CATAWBA NUCLEAR STATION, UNIT NOS. 1 AND 2
DOCKET NOS. 50-413 AND 50-414
RENEWED LICENSE NOS. NPF-35 AND NPF-52

MCGUIRE NUCLEAR STATION, UNIT NOS. 1 AND 2
DOCKET NOS. 50-369 AND 50-370
RENEWED LICENSE NOS. NPF-9 AND NPF-17

**SUBJECT: SUPPLEMENT TO LICENSE AMENDMENT REQUEST PROPOSING
CHANGES TO CATAWBA AND MCGUIRE TECHNICAL SPECIFICATION 3.8.1,
“AC SOURCES - OPERATING”**

Supplemental Information Needed for Acceptance of Requested Licensing Action

Intake Section

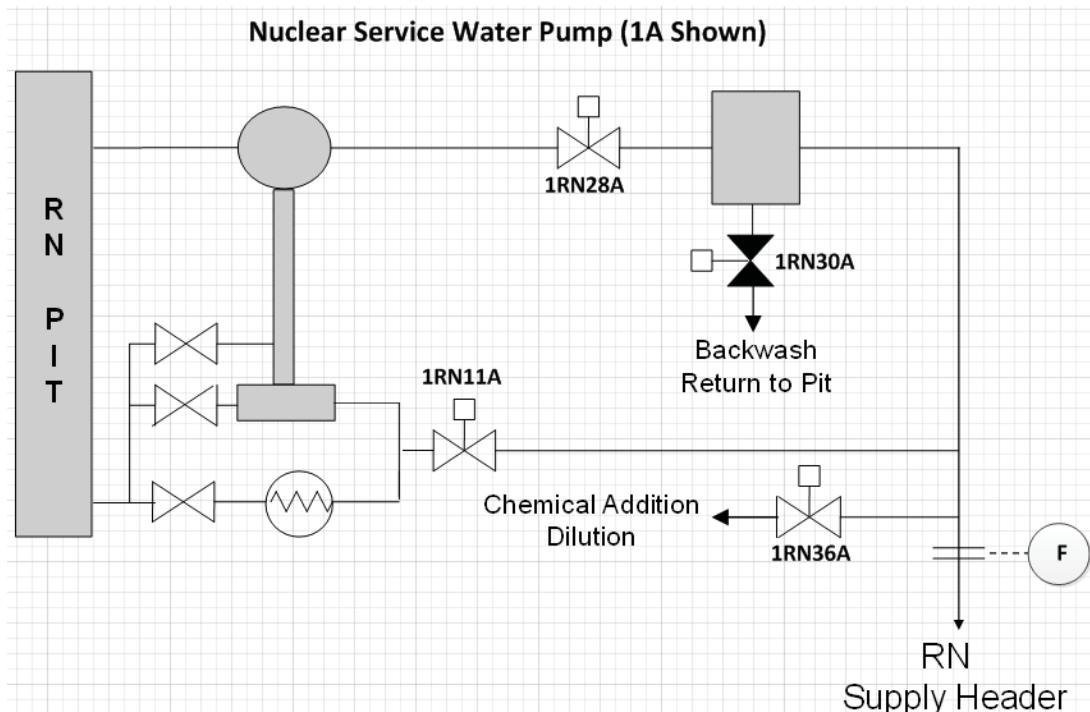
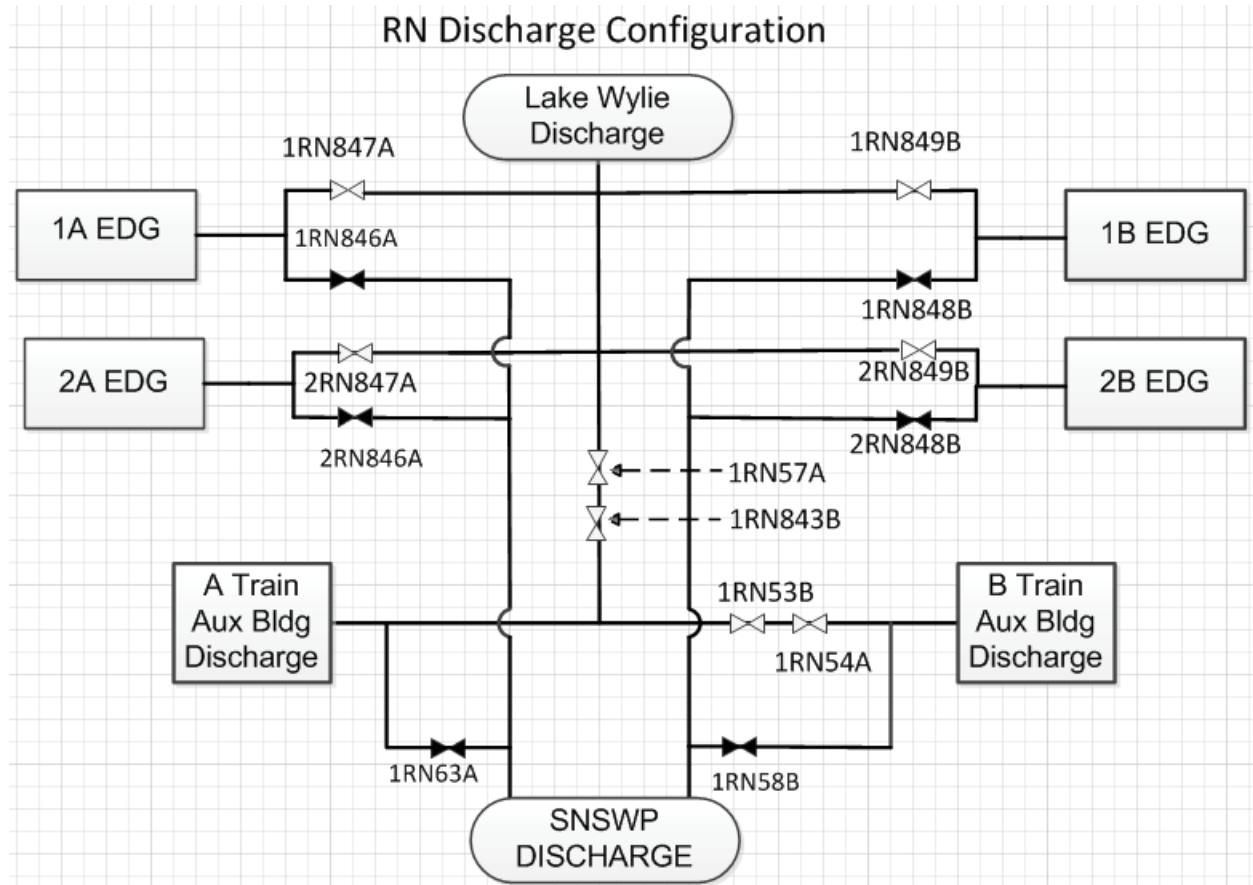
- a. Provide in detail the effects of a loss of each DG would have upon the shared SSCs of the Catawba and McGuire NSWS system to evaluate the effect upon each unit.

Valves 1RN1A and 1RN2B are normally open to align Lake Wylie to Nuclear Service Water Pump Intake Pit A. Nuclear service water pumps 1A and 2A draw suction from intake pit A. Valves 1RN1A and 1RN2B close on emergency low level in either RN pumphouse pit (based on 2 out of 3 logic from single pits level instruments) to isolate the RN System from Lake Wylie for RN alignment to the Standby Nuclear Service Water Pond (SNSWP).

A loss of the 1A EDG would potentially result in the inability of valves 1RN1A and 1RN5A to close if there was a concurrent loss of offsite power and a dam failure resulting in a low intake pit level. The corresponding B train valves, 1RN2B and 1RN6B, would close to prevent the drainage of the SNSWP to the empty Lake Wylie.

The single train related supply valves from the SNSWP, 1RN3A and 1RN4B, are normally closed. Upon receipt of a low intake pit level, these valves open to provide the assured RN system supply from the SNSWP. In the loss of EDG 1A and dam failure event, 1RN3A may remain closed; however, 1RN4B would open to supply water to the RN system.

The loss of EDG 1A would prevent RN Pump 1A from receiving a start signal which would prevent 1RN28A and 1RN11A from opening. 1RN30A would be incapable of opening to support RN Pump 1A operability. 1RN36A would also not be capable of closing; however, the B train valve, 1RN37B, would close to meet train separation requirements.
